PROJECT: Summitin Village 24 Parcels FGH Units 1, 2 and 3 Update

CITY OF LAS VEGAS INTER-OFFICE MEMORANDUM		DATE: September 24, 2020
TO: Land Development Services Department of Building & Safety		FROM: Albert Sung, P.E. Flood Control Project Engineer Department of Public Works
SUBJECT:	Drainage Study for:	
	Summerlin Village 24 Parcels FGH - Units 1, 2 and 3 - Update	
Cross Streets:	Crossbridge Drive & Sky Vista Drive	
File Number:	F:\Depot\DSMemos\DS5210E.doc	
Parcel Number:	164-04-511-001	
Zoning Action:	TMP-76536	
FEMA Flood Zone	YES	NO X
Proposed Storm Drain	YES X	NO
COPIES TO:		
		RCI Engineering
		Lennar Communities Nevada, LLC
		Bart Anderson, P.E., DevCo
		CCPW
		BLM

3rd Submittal: Update to revise some storm drains from RCP to C900 PVC in compliance to recent changes of LVVWD and SNHD criteria

**UPDATE TO THE
TECHNICAL DRAINAGE STUDY
For
SUMMERLIN VILLAGE 24 PARCELS FGH
Units 1, 2 and 3**

DATE: 1-23-20
P-4
SHEET 23 OF 42
CLV DRAWING NUMBER
CLV PROJECT #

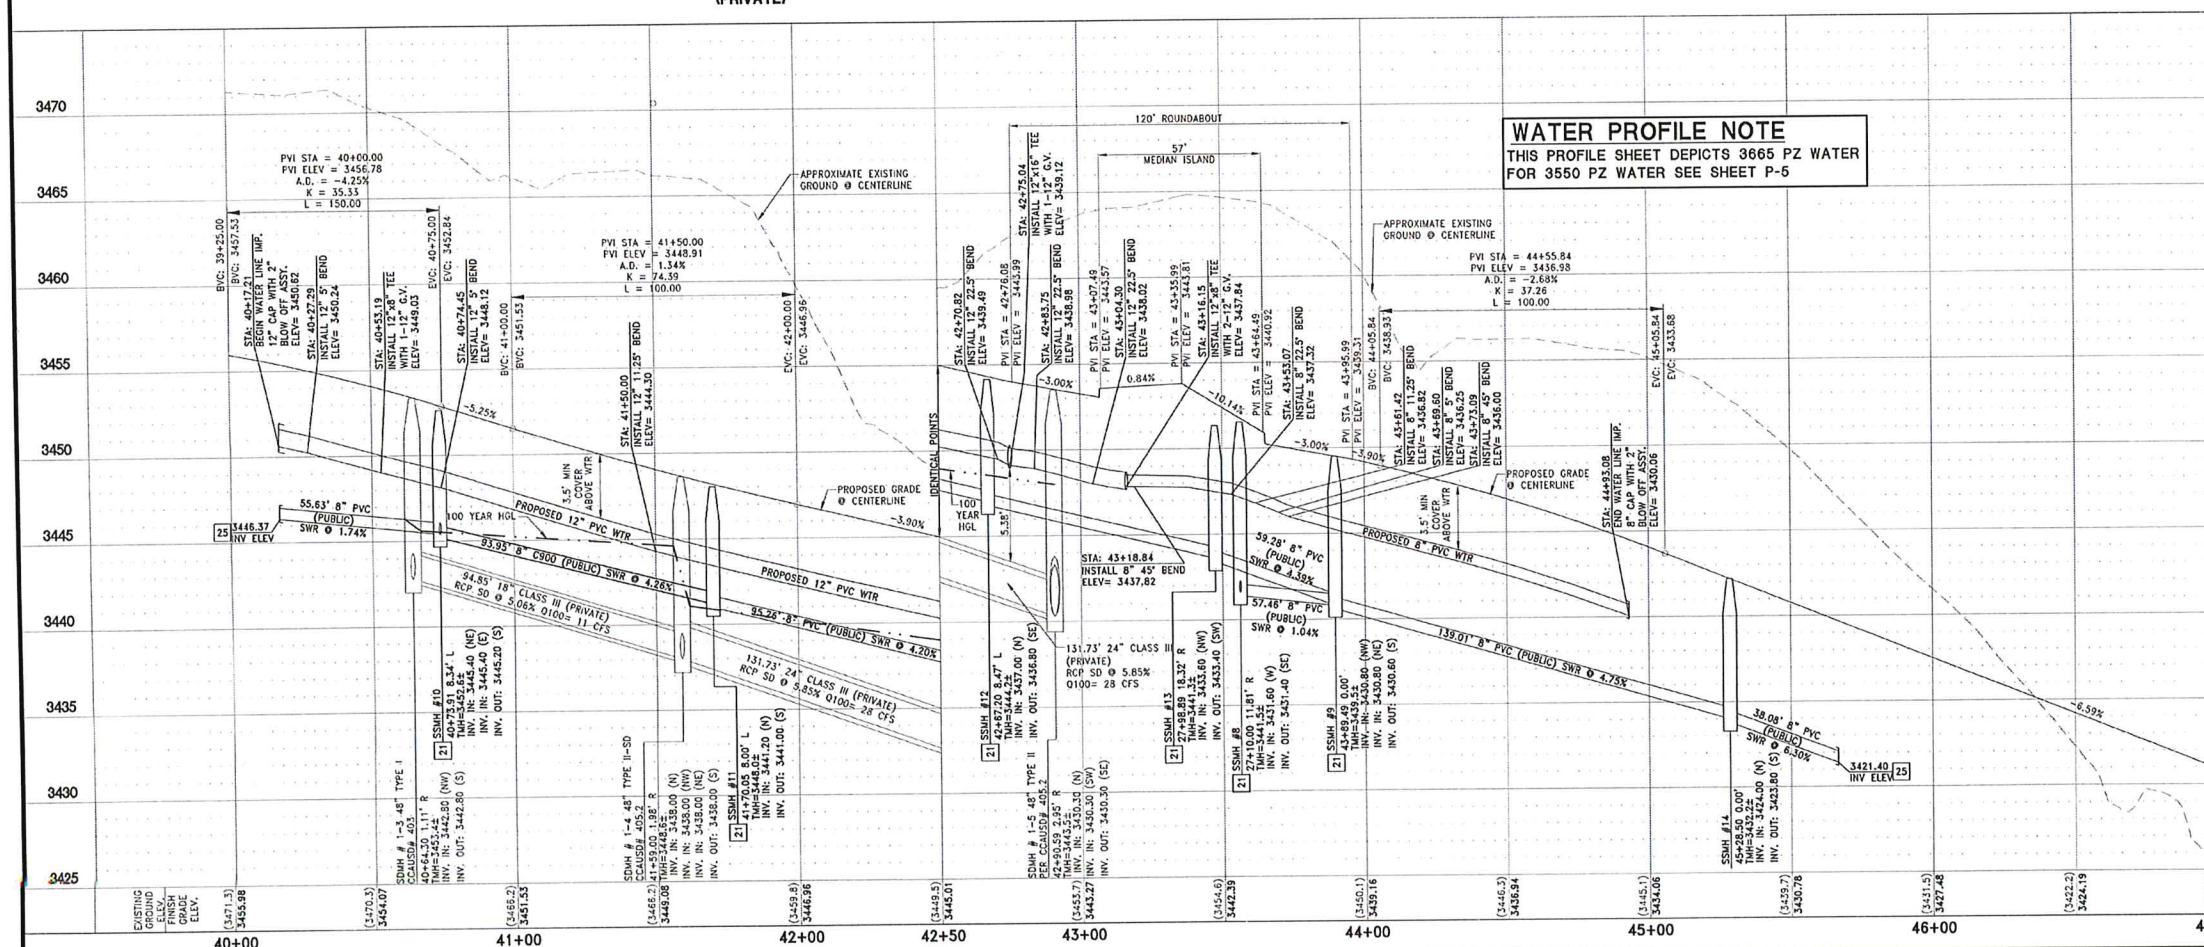
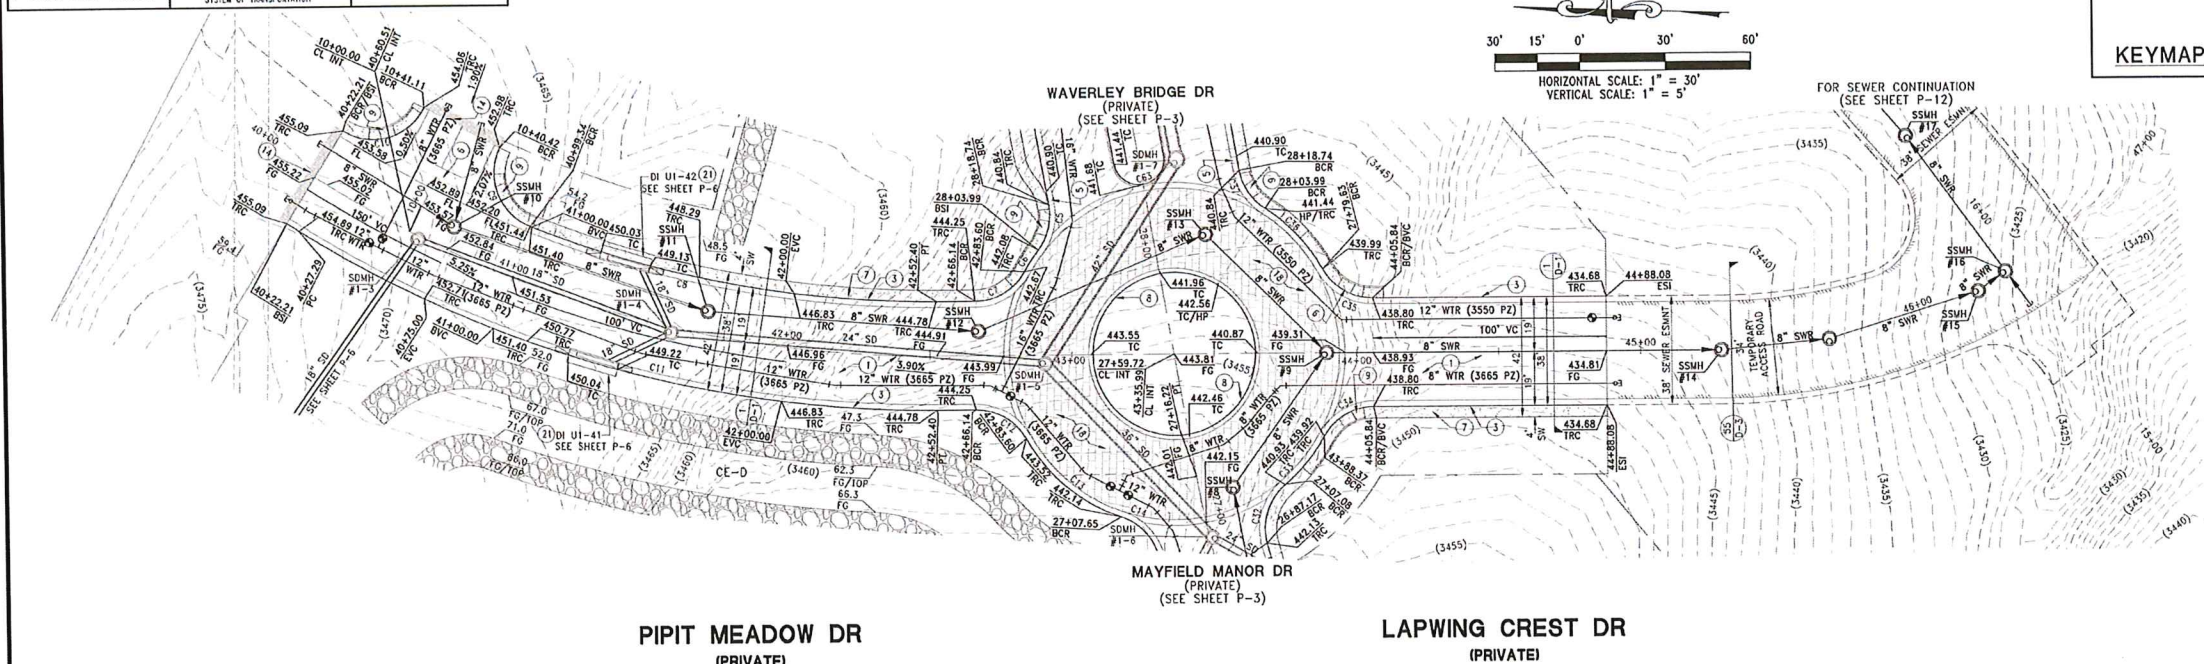
Sheet P-4

DATE: 1.13.20
DRAWING
P-5
SHT 24 OF 42
CLV DRAWING NUMBER

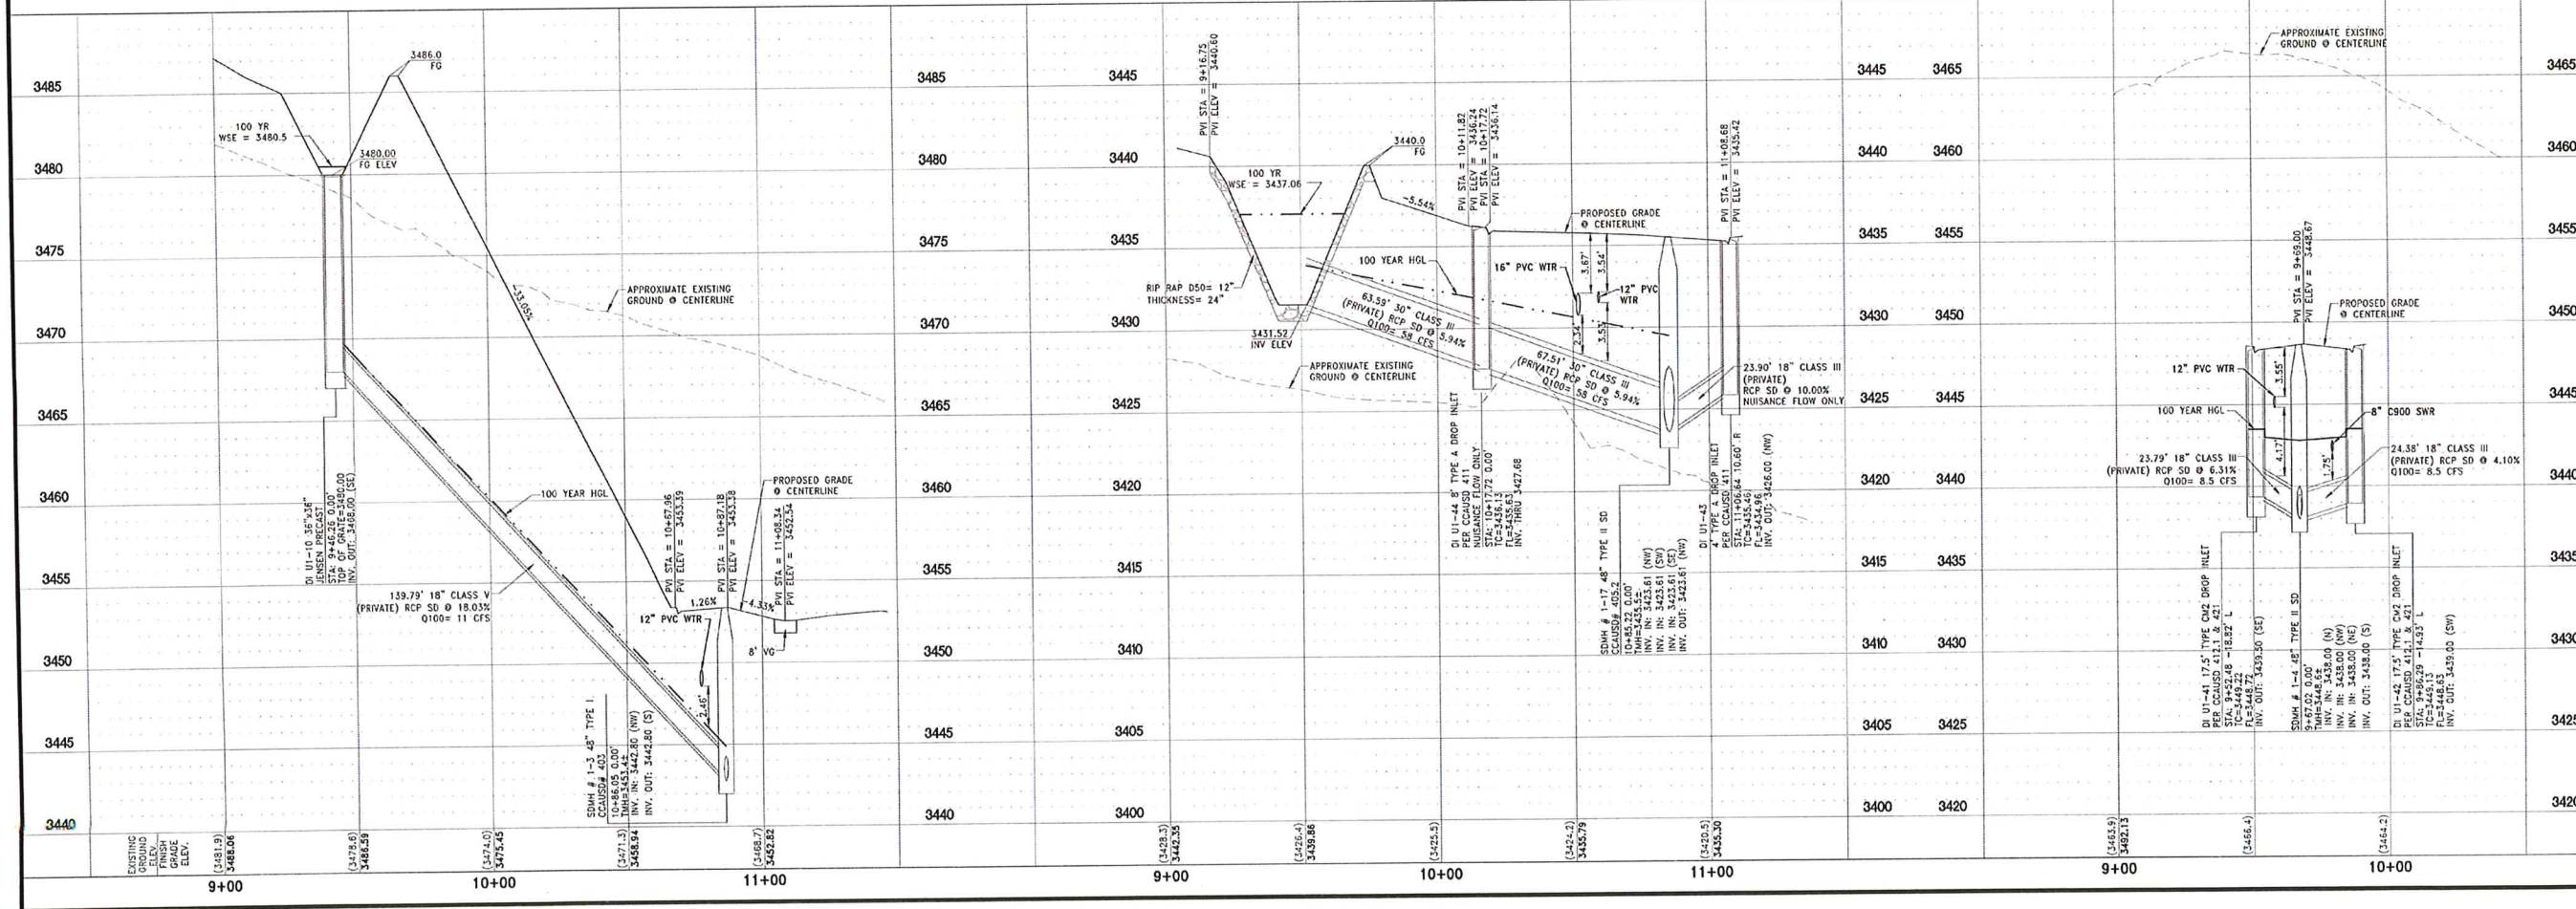
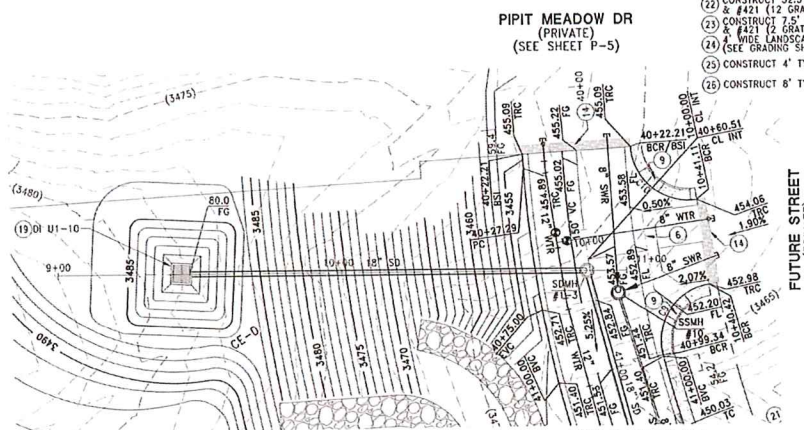
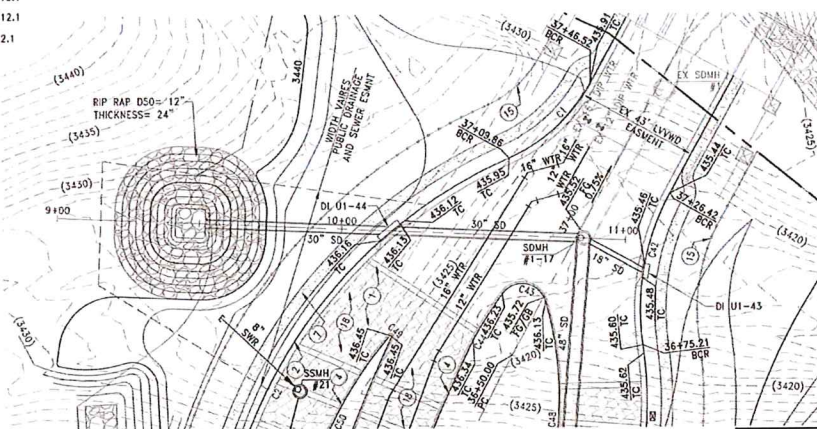
Sheet P-5

DATE: 1-23-20
DRAWING
P-6
SHEET 25 OF 42
CLV PROJECT #

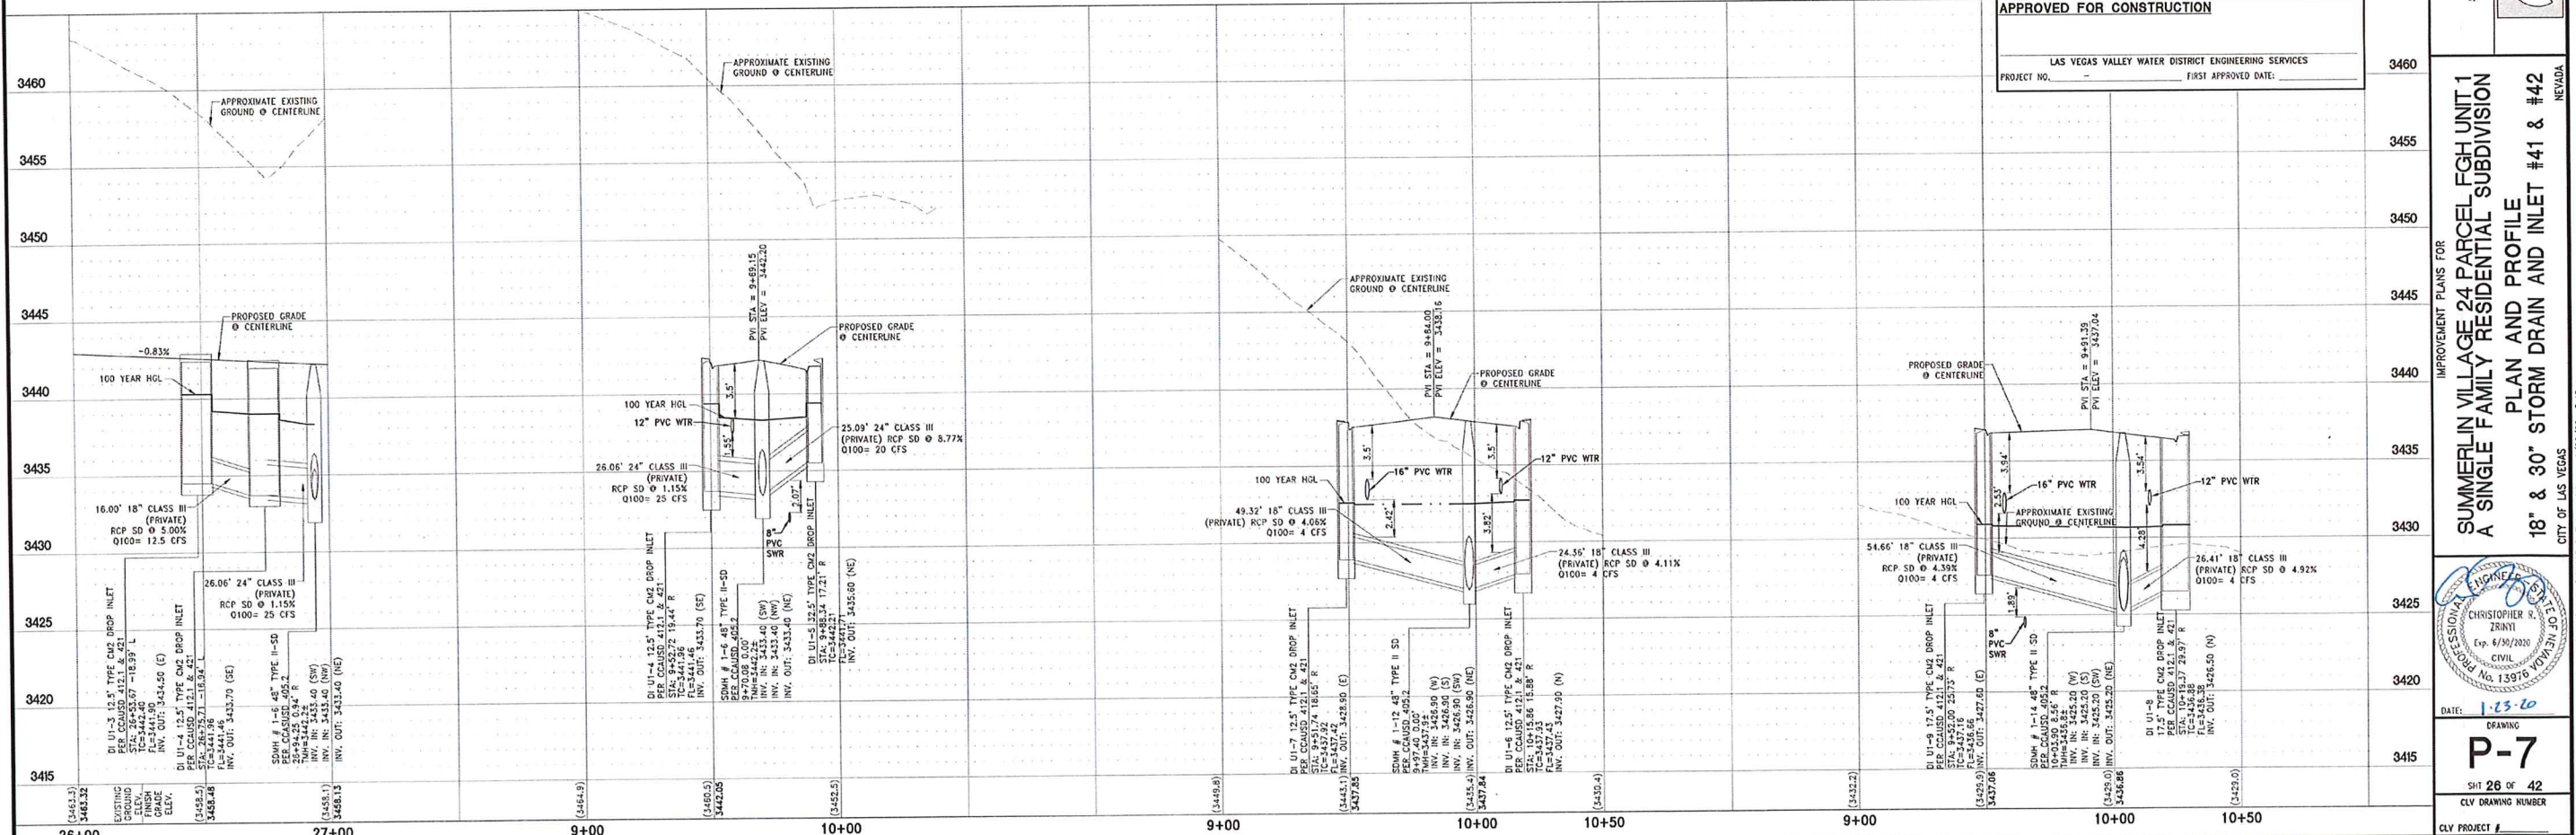
Sheet P-6
